Staff Report

Re: PLNPCM2022 - 00141 West Quarter Block C

Design Review

PROPERTY ADDRESS: 260 W 200 S **PARCEL ID:** 15-01-207-038-0000

EXISTING TREE TO BE REMOVED 5

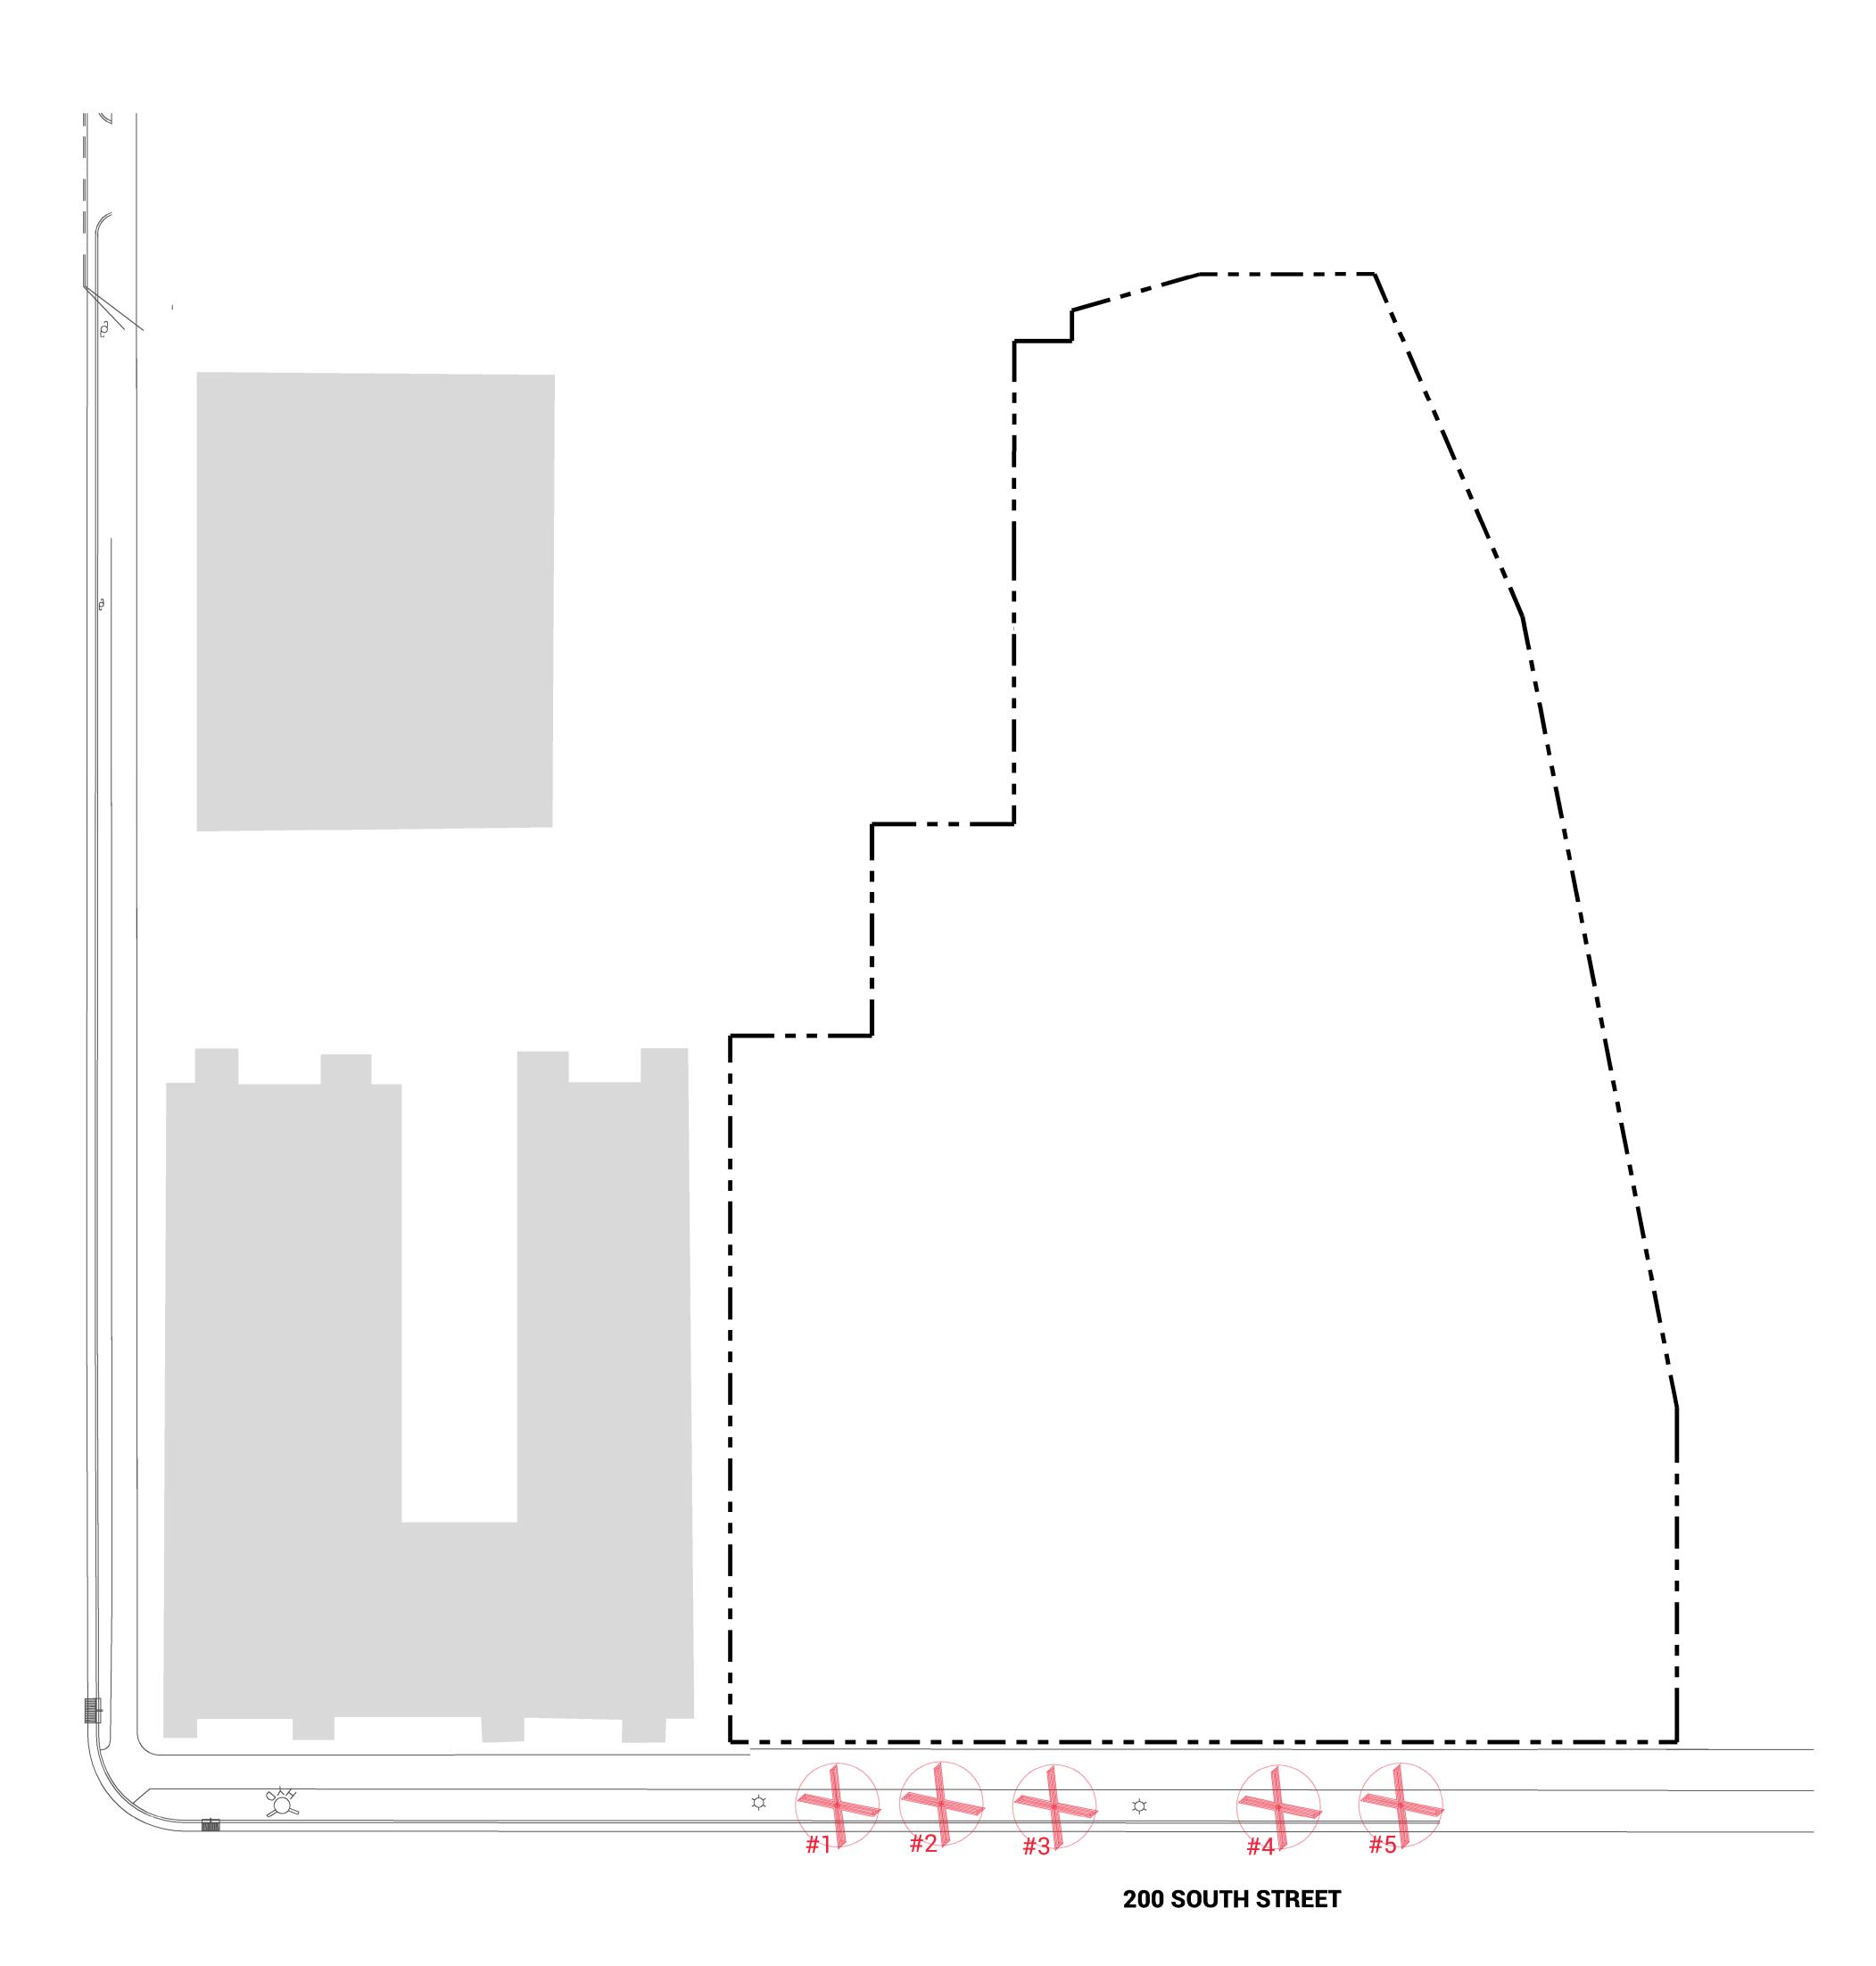
Please note, preservation and protection of the existing street trees will be recommended to the Planning Commission as a condition of approval. - New trees are on teh approved list from Urban Forestry and agreed upon in lieu of keeping the existing trees

Trees removed documented on sheet LT101 Tree Removal Plan.

LS101

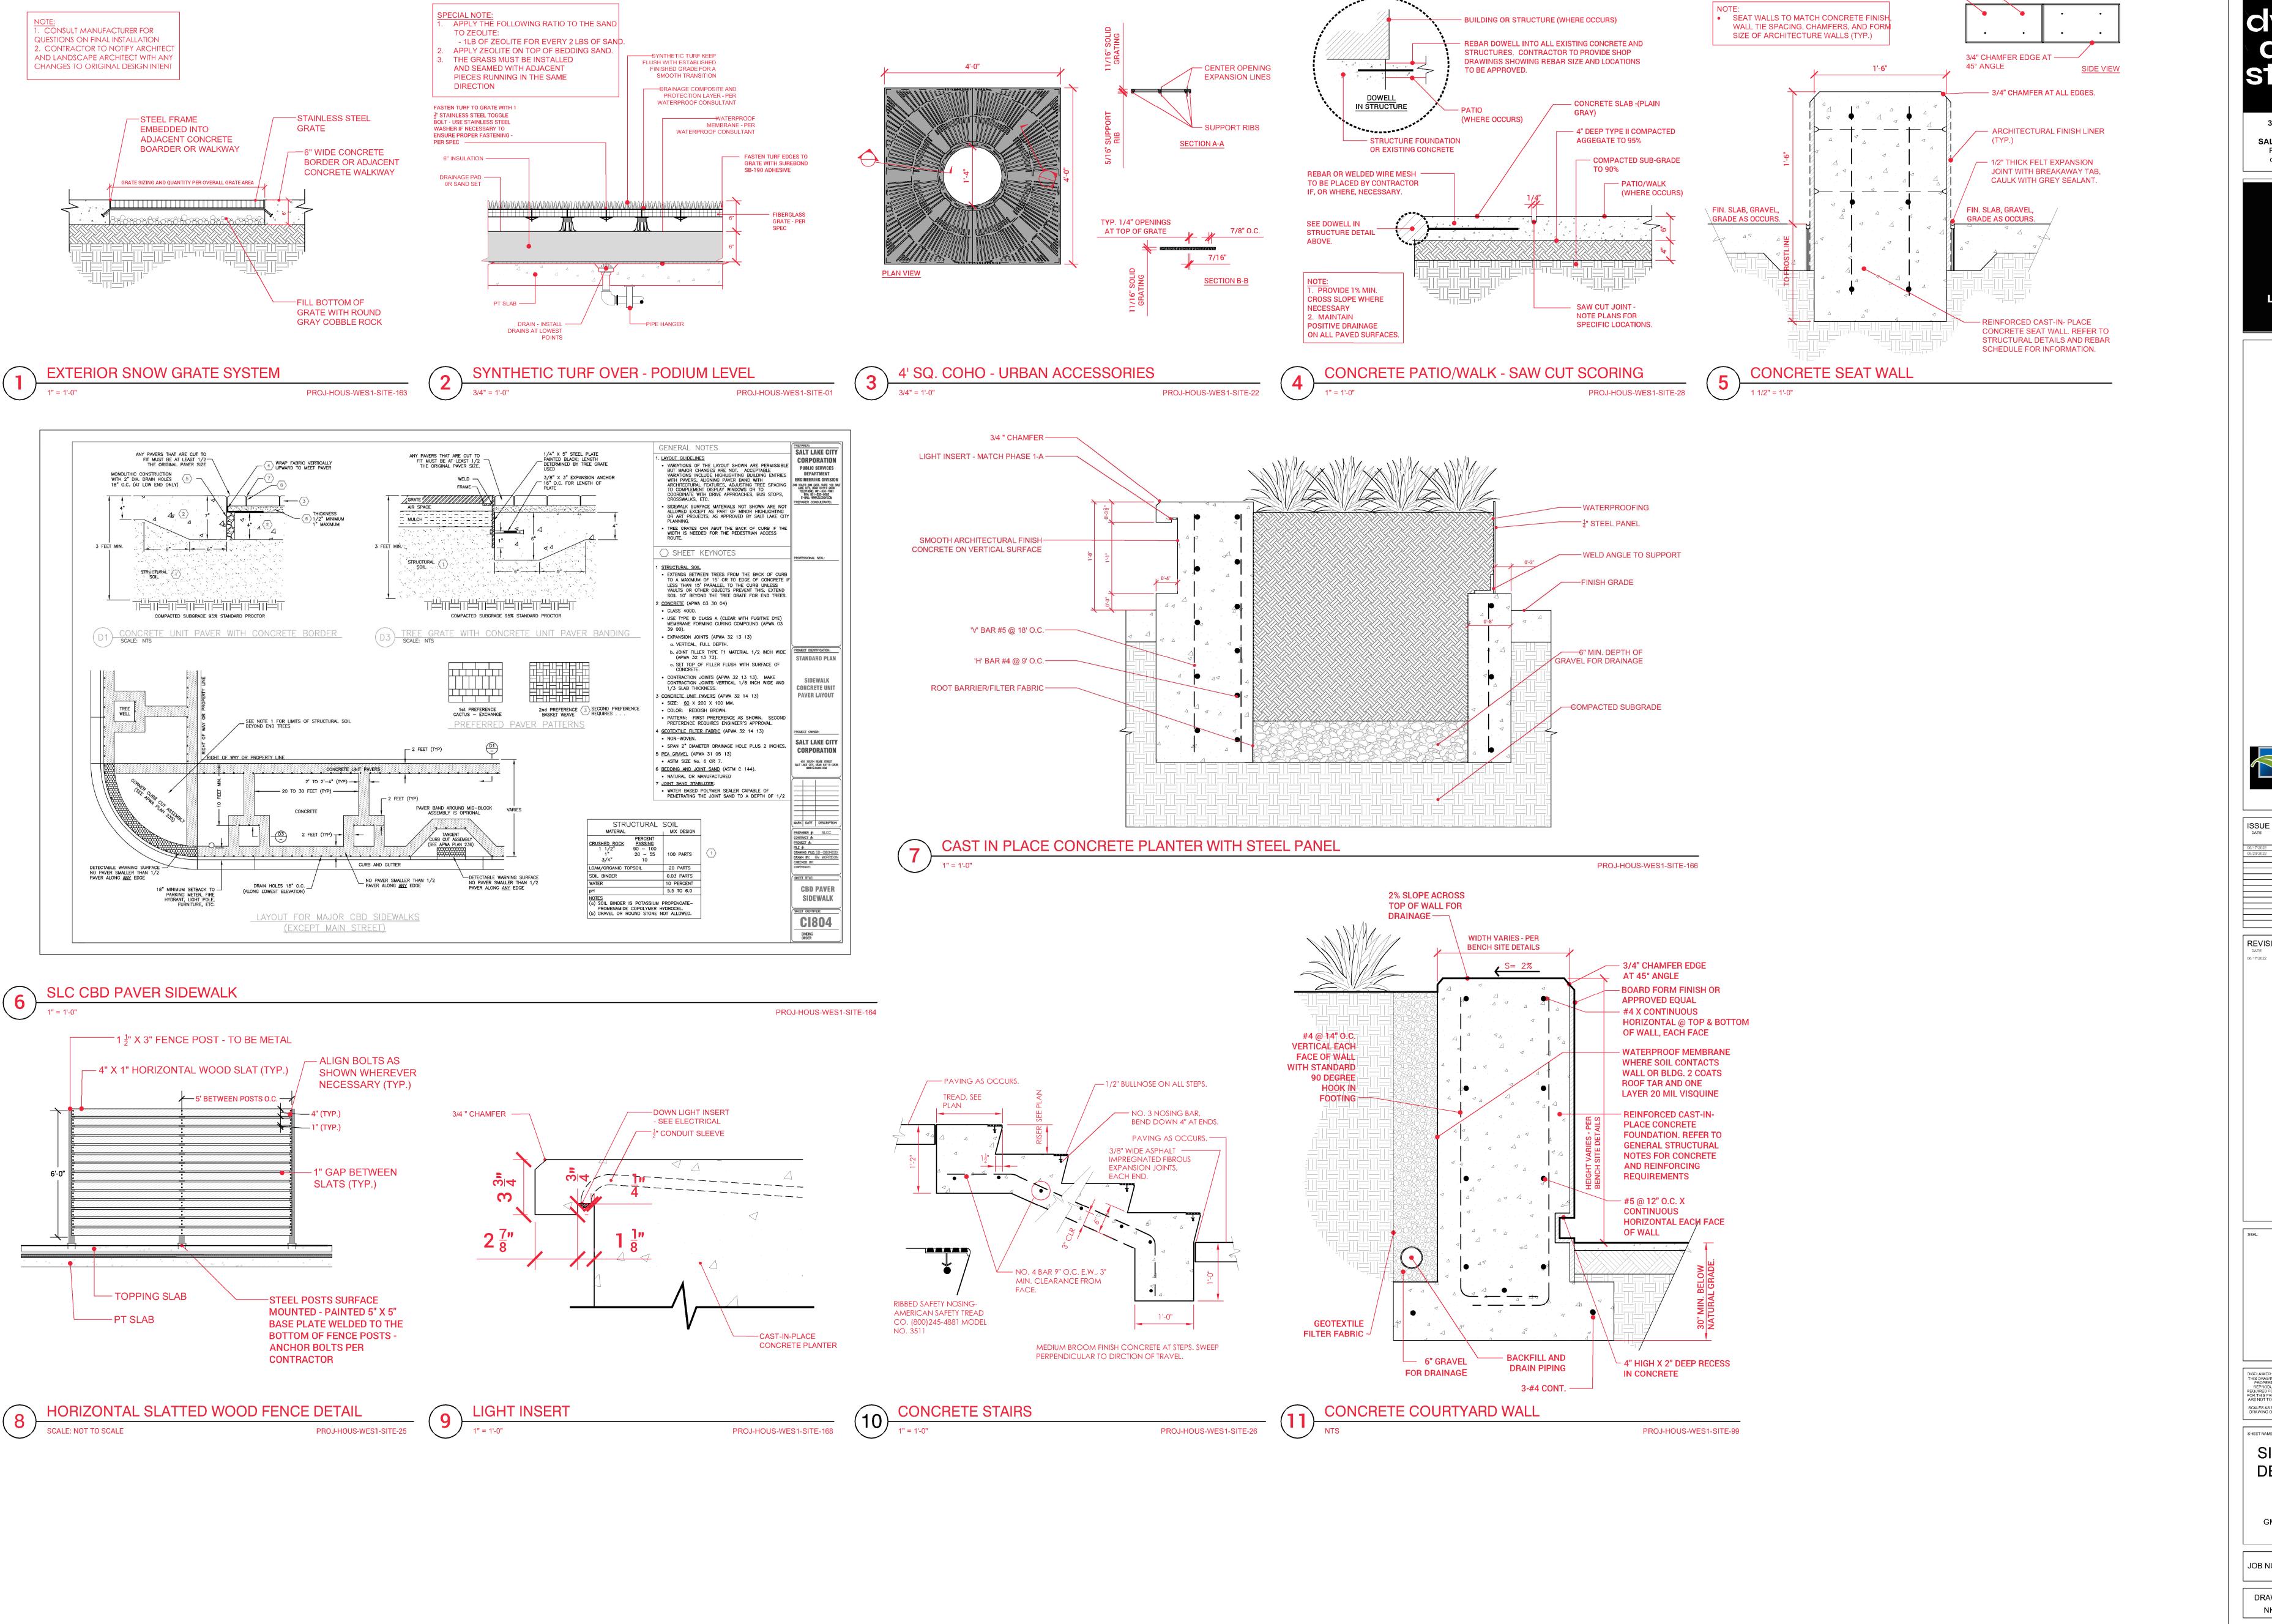
F.1: Correction Required: This standard has very specific requirements for outdoor seating (see below). Please provide details indicating how the proposed sitting space will meet the requirements. Please label where each element (the proposed sitting space, outdoor dining and shade) is located on the site plan. "1. Sitting space of at least one sitting space for each two hundred fifty (250) square feet shall be included in the plaza. Seating shall be a minimum of sixteen inches (16") in height and thirty inches (30") in width. Ledge benches shall have a minimum depth of thirty inches (30")."

See attached letter response and sheet LS101 for response.

Forty (40) seats required by code to meet the 1 seat per 250 square feet requirement. One hundred fifty-three (130) seats provided by seatwalls, benches, and chairs.

Each seating element noted on Site Layout sheet LS101. See notes L-06, L-37, L-50, and 3D Detail callouts.
